Service Bulletin

Subject: Unable to Manually Unlock the Driver Door Using Key from the FOB

Models: 2015 Cadillac ATS Coupe
Export RPO - UTT, Built Prior to December 5, 2014

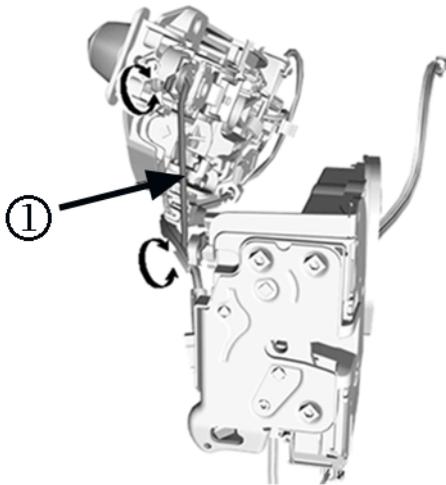
The cause of this condition may be that the driver door may have been built using the incorrect lock rod. This incorrect lock rod will not allow the door to manually unlock using the key.

Verify the customer concern and replace the driver door lock rod on vehicles where this condition is found.

1. Remove the driver door lock rod (1). Refer to Front Side Door Lock Cylinder Rod Replacement (Coupe) in SI.
2. Install the new lock rod. Refer to Front Side Door lock cylinder Rod Replacement (Coupe) in SI.
